TOWN OF CARMEL PLANNING BOARD

PLANNING BOARD AGENDA **DECEMBER 17, 2020 – 7:00 P.M.**

RE: Stillwater Business Park
105 Stillwater Road
Town of Carmel
TM#s 75.17-1-53, 86.5-1-25, & 86.5-1-26

**Re: Site Plan for DP-53, LLC – Spins Bowl**  
*Site Plan Application – Responses to Comments*

DRAWING:  
**LAYOUT AND LANDSCAPE PLAN**

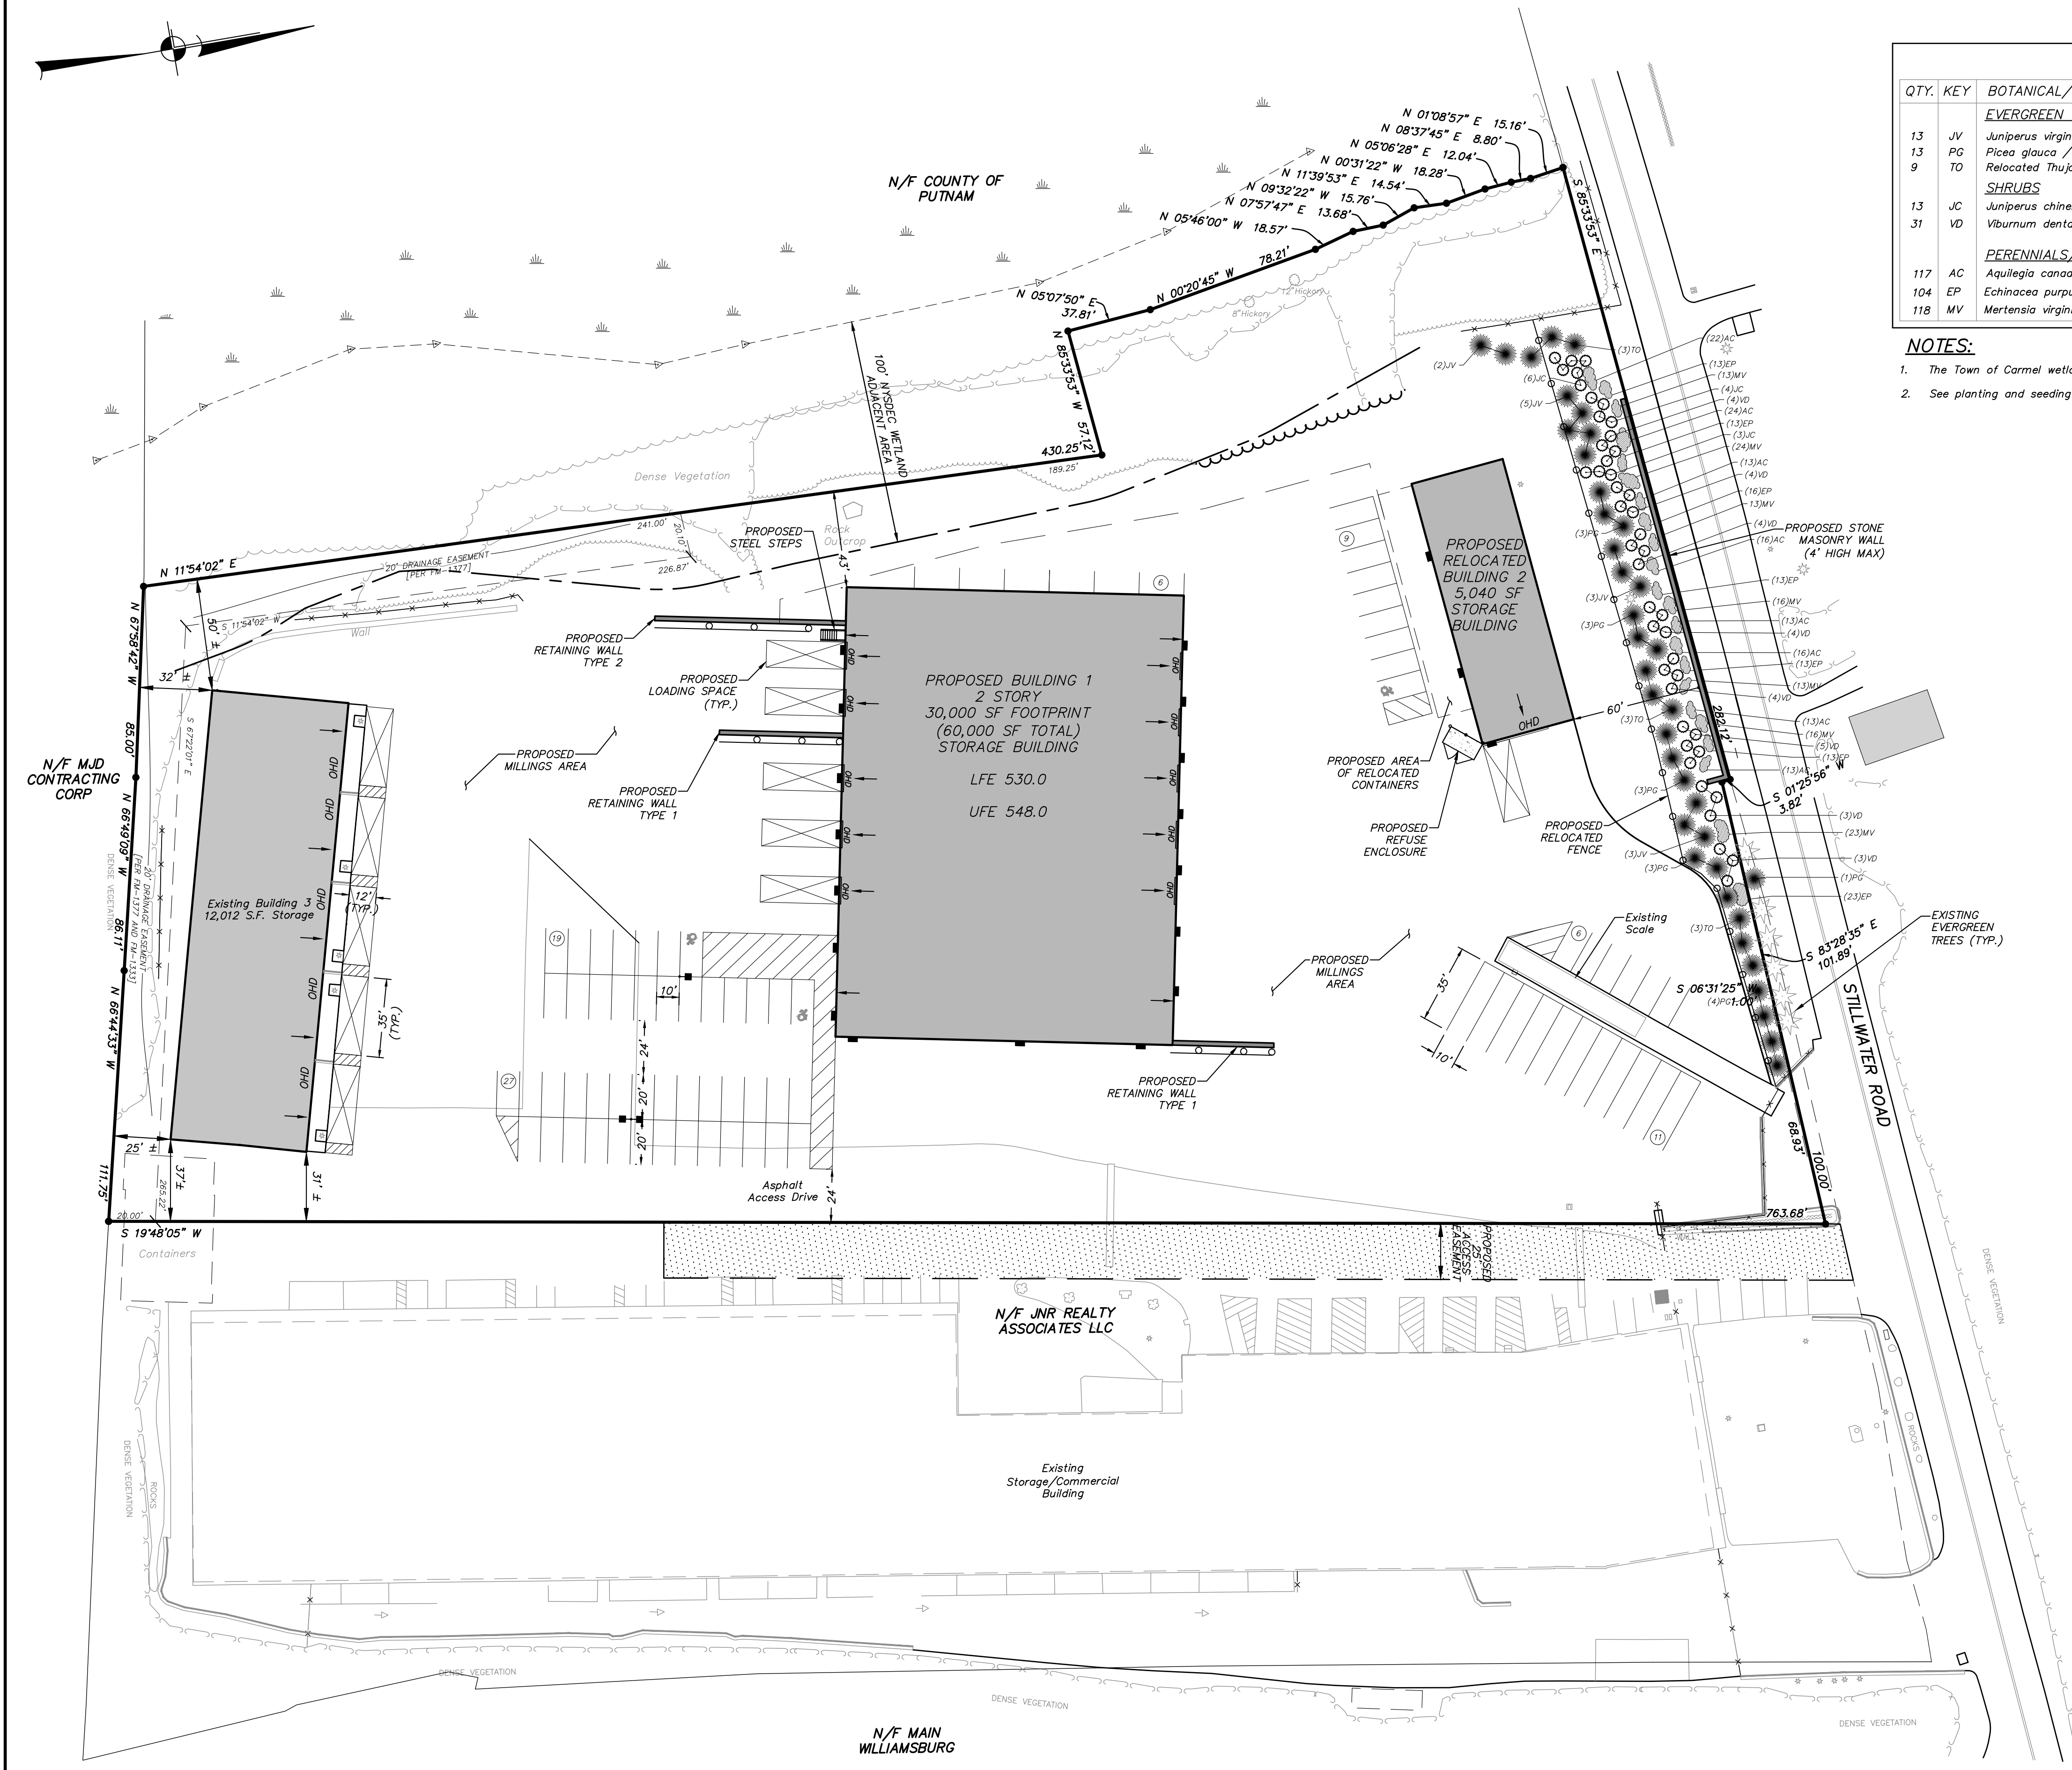
4. The applicant has agreed to accommodate the request to eliminate the westerly driveway and the enclosed plans have been modified accordingly.
5. As suggested, during the Public Hearing the northerly building has been shifted slightly to the west to provide further screening of the site.

DRAWING:  
VEHICLE MANEUVERING AND  
LIGHTING PLANS

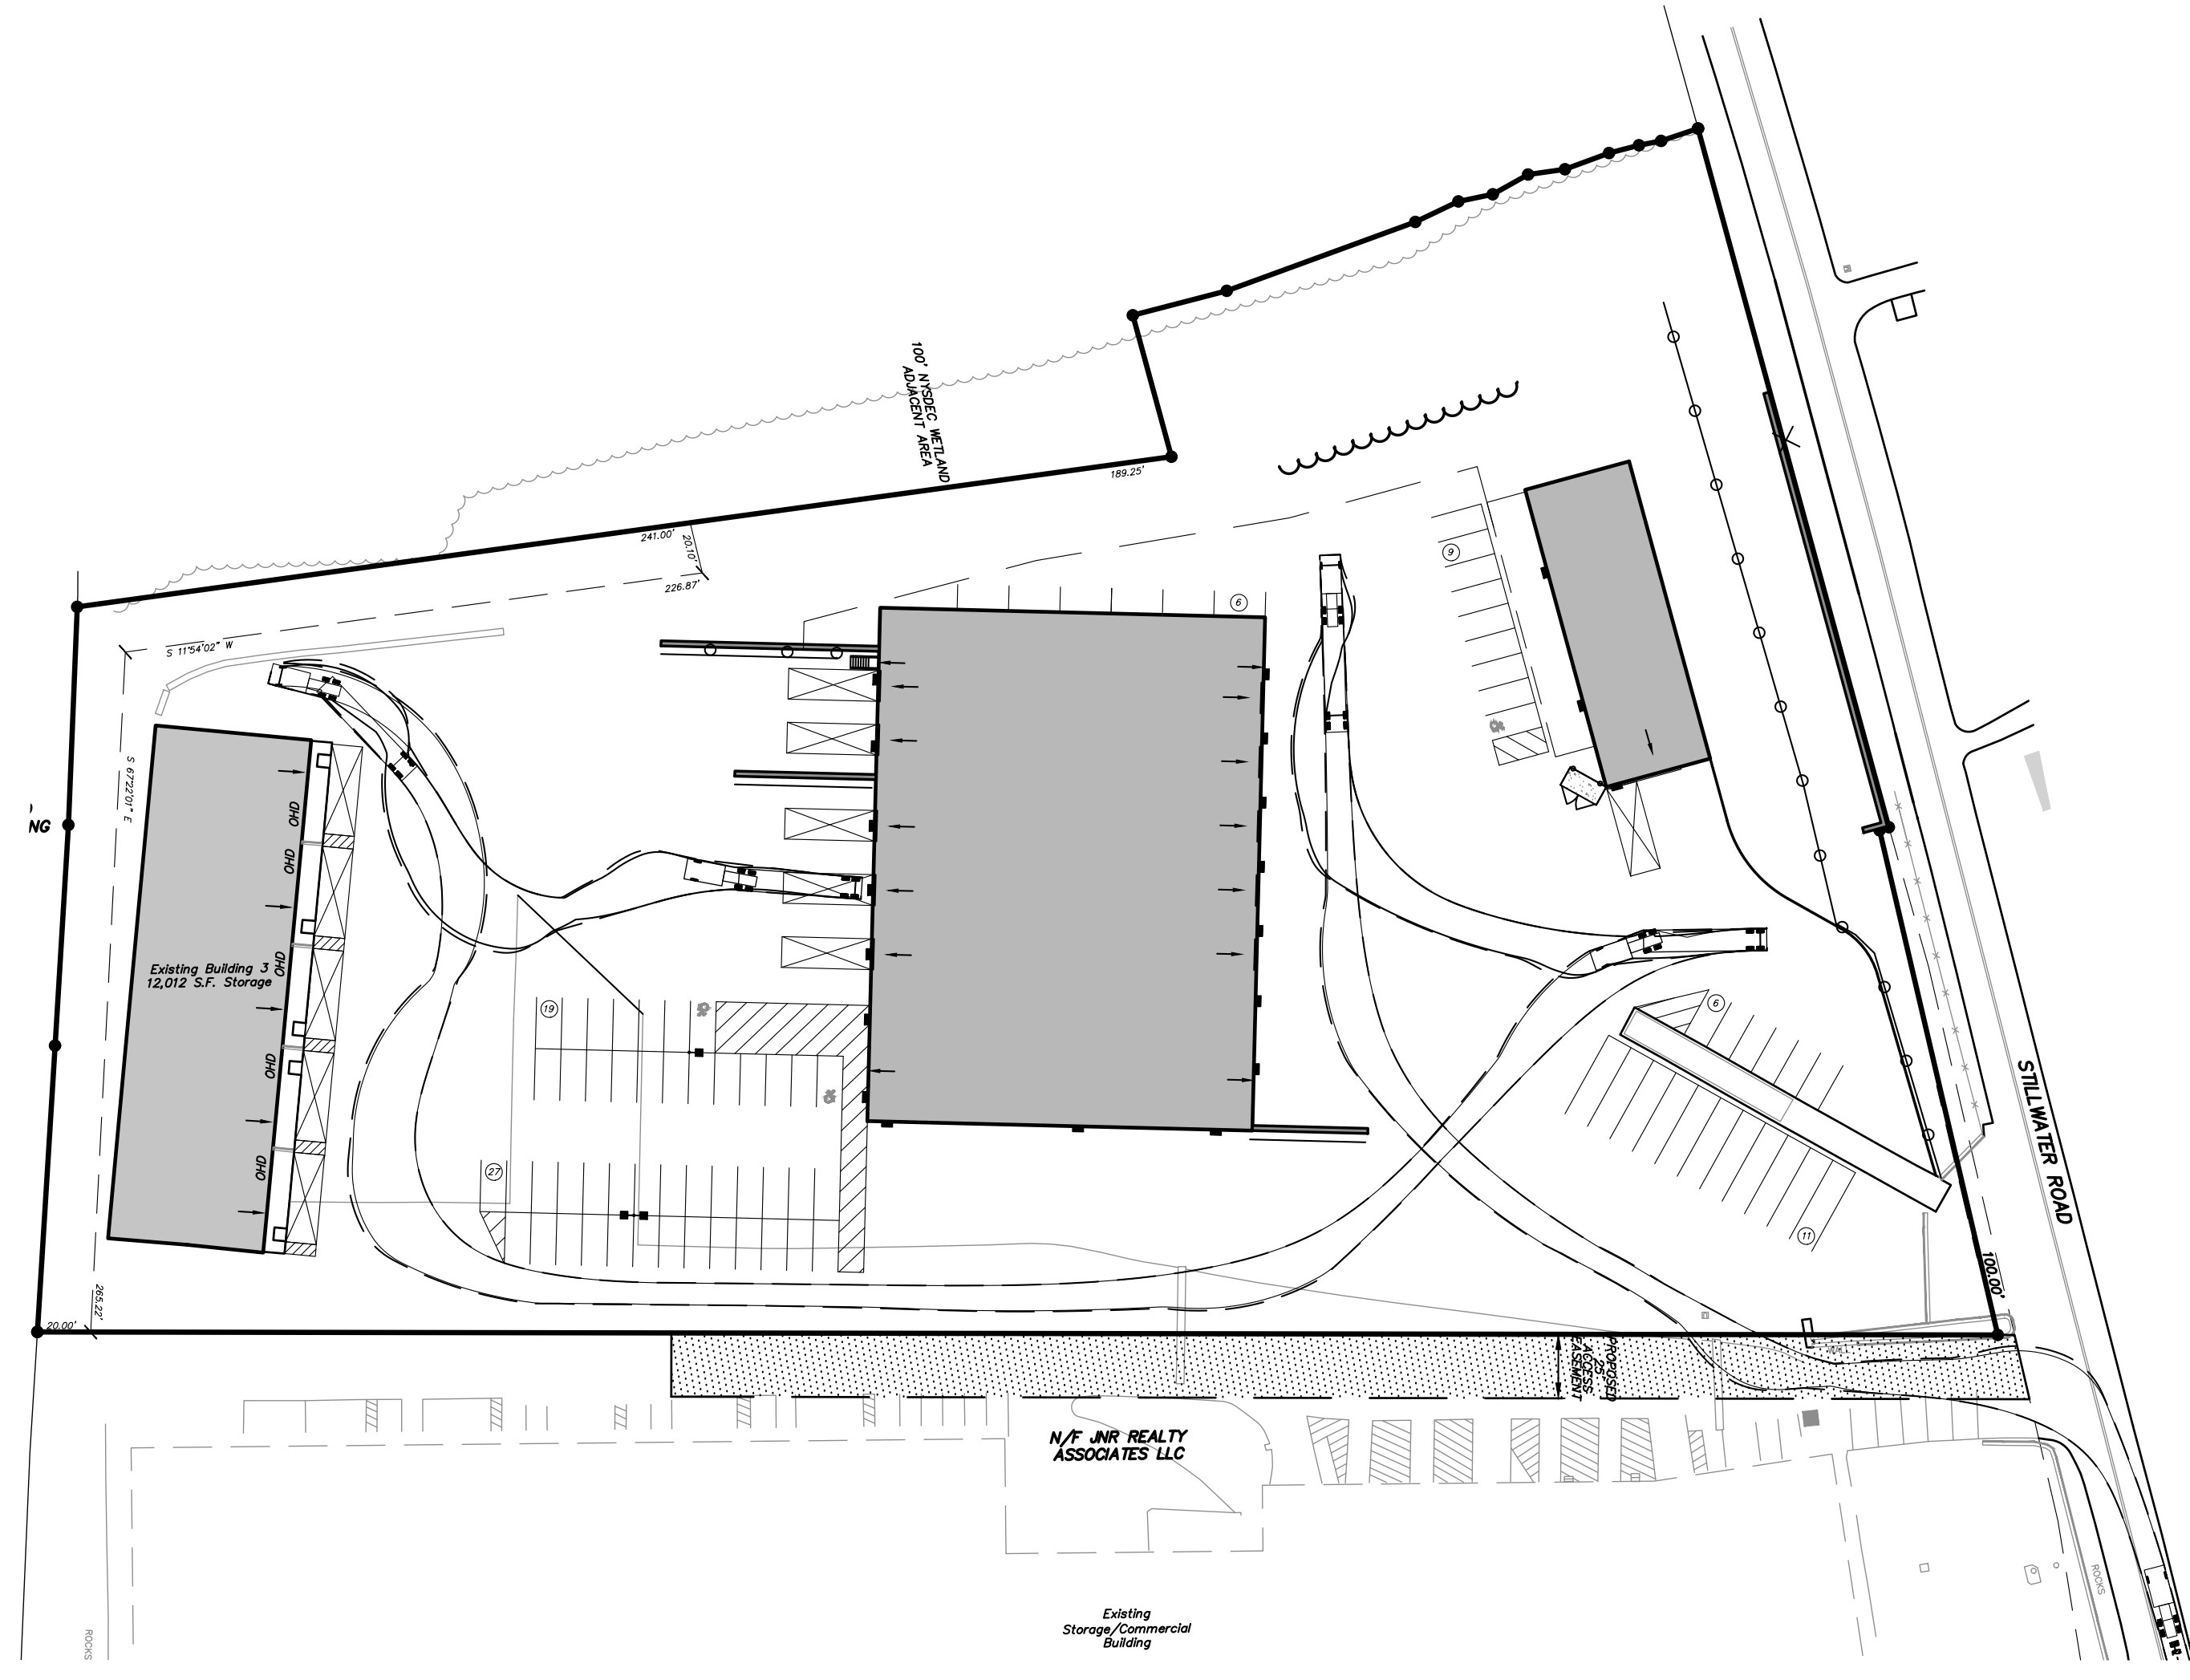
6. The proposed site lighting has been reviewed and revised to ensure efficient site lighting while minimizing spillage. Also note the proposed lighting is "dark sky" compliant in accordance with the latest recommended standards.
7. Reference to the fencing along Stillwater Road has been addressed by relocating the fencing behind the proposed stone wall and landscape buffer as indicated on the revised site plans.
